Taco Time

PROJECT DESCRIPTION
CONSTRUCTION OF NEW RESTAURANT BUILDING, EXPANSION
OF EXISTING PARKING LOT WITH ASSOCIATED CIVIL IMPROVEMENTS.

Cover Sheet

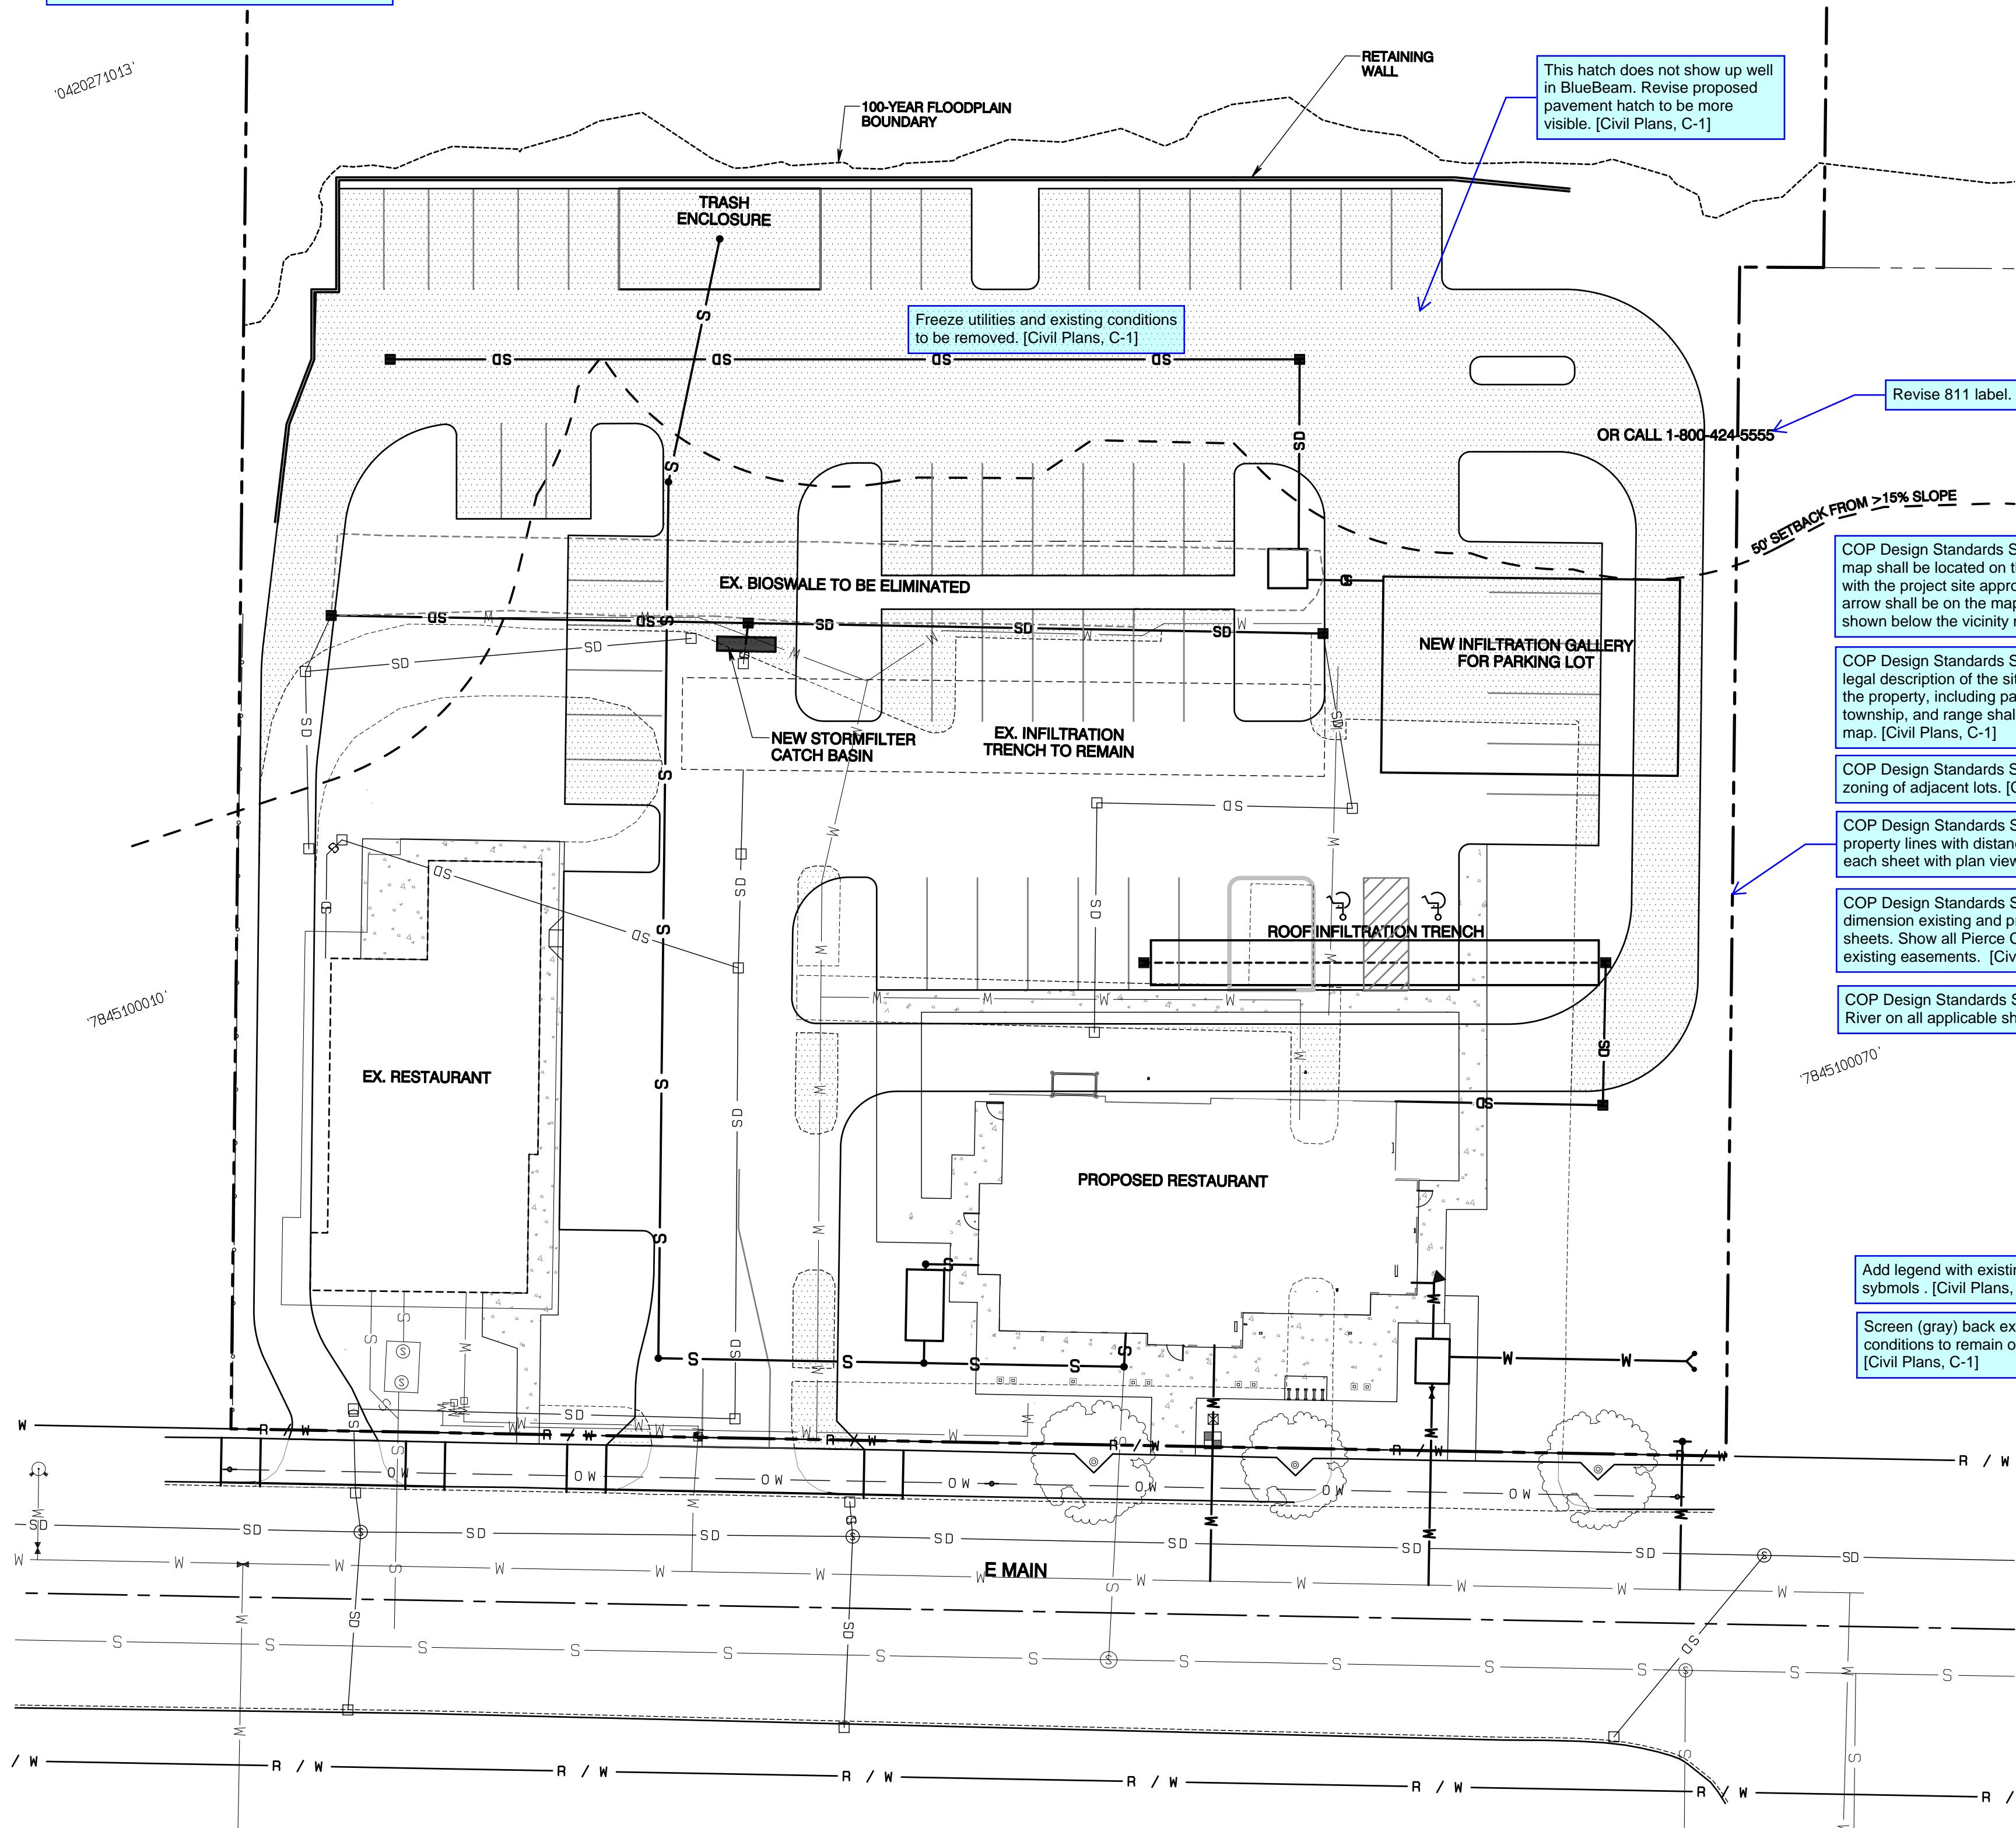
Add monument protection note. [Civil Plans, C-1]

Erosion & Sediment Inspection is completed
through CityView Portal after pre-construction
meeting. This note is not required to be on the
plans. [Civil Plans, C-1]

Add existing and proposed surface area table from
Preliminary Site Plan Submittal. Use the table format
given separately under Docs & Images. Additionally
break up new plus replaced hard surfaces and effective
new plus replaced hard surfaces into the separate
TDAs. Provide [Civil Plans, C-1]

Show fill and/or excavation quantities
in cubic yards. [Civil Plans, C-1]

Add note, "A separate building permit is
required for trash enclosure" [Civil Plans, C-1]

This hatch does not show up well
in BlueBeam. Revise proposed
pavement hatch to be more
visible. [Civil Plans, C-1]

Add Grading plan with spot elevations, slope labels,
and proposed topography. [Civil Plans, C-1]

Revise 811 label. [Civil Plans, C-1]

COP Design Standards Section 2.1(10): The vicinity
map shall be located on the lower right of the first sheet
with the project site approximately centered. A north
arrow shall be on the map. The site address shall be
shown below the vicinity map. [Civil Plans, C-1]

COP Design Standards Section 2.1(11): Add a brief
legal description of the site, in enough detail to locate
the property, including parcel number, 1/4 section,
township, and range shall be located below the vicinity
map. [Civil Plans, C-1]

COP Design Standards Section 2.1(13): Add current
zoning of adjacent lots. [Civil Plans, C-1]

COP Design Standards Section 2.1(14): Label
property lines with distance and bearings on
each sheet with plan view. [Civil Plans, C-1]

COP Design Standards Section 2.1(19): Show and
dimension existing and proposed easements on all
sheets. Show all Pierce County recording numbers for
existing easements. [Civil Plans, C-1]

COP Design Standards Section 2.1(22): Label Puyallup
River on all applicable sheets. [Civil Plans, C-1]

This additional Vicinity map is not
necessary. If it is kept, frame it with
scale and north arrow. Freeze utilities,
hatches, trees, setbacks, and label
street, river, new buildings and ex
buildings. [Civil Plans, C-1]

Add legend with existing and proposed lines and
symbols. [Civil Plans, C-1]

Screen (gray) back existing
conditions to remain on all sheets.
[Civil Plans, C-1]

COP Design Standards Section 1.0(1.4):
Approval block should be 2-1/4" x 3-1/4".
[Civil Plans, C-1]

Existing Conditions & Demolition Plan

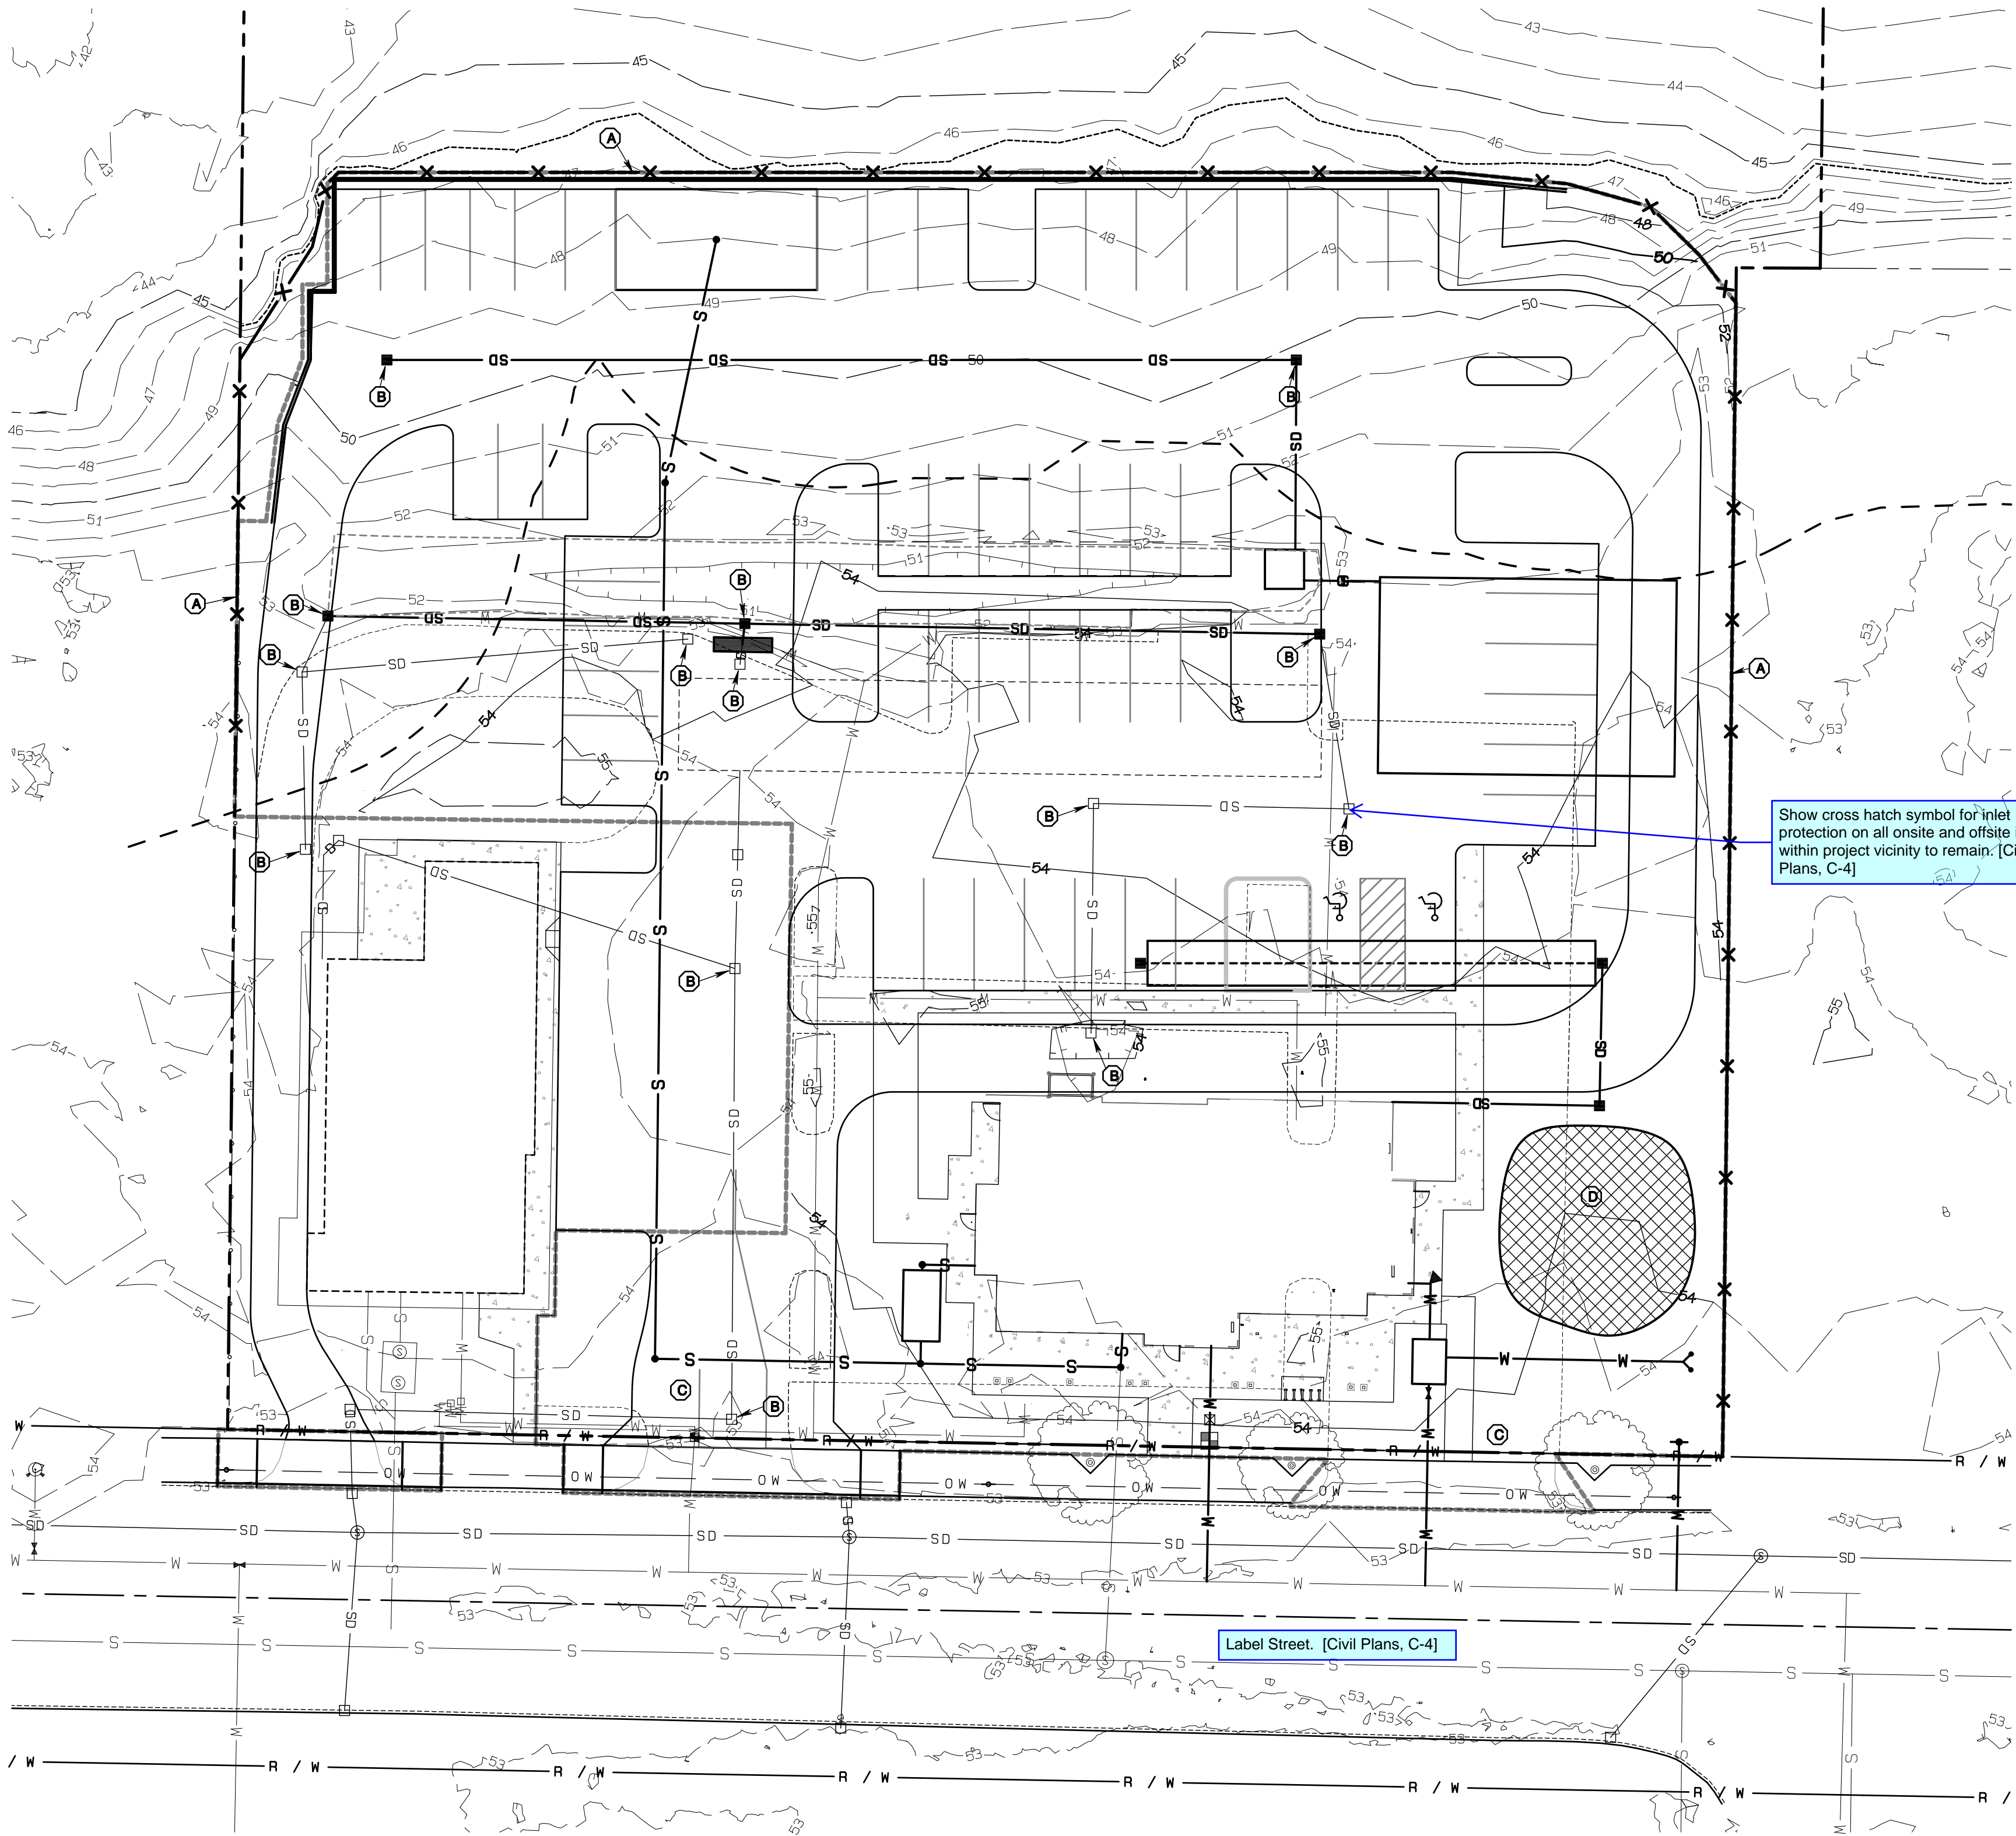
There are no proposed items on this sheet. update legend to show applicable lines and symbols. [Civil Plans, C-3]

Is this a wall? specify whether it is to remain or be removed. [Civil Plans, C-3]

Pavement removal limits don't match proposed pavement limits. Sawcuts should be straight lines. [Civil Plans, C-3]

Clarify through callouts and labels every item to remain and every item to be removed. [Civil Plans, C-3]

Show Existing FFE on all sheets with contours. [Civil Plans, C-3]

add all symbols and lines in legend and add callouts in planview. [Civil Plans, C-3]

Are these trees proposed? Callout what this sawcut patch is for. [Civil Plans, C-3]

Show street curb as curb and gutter on all sheets. [Civil Plans, C-3]

Show grind an overlay on plans. [Civil Plans, C-3]

Callout what this sawcut patch is for. [Civil Plans, C-3]
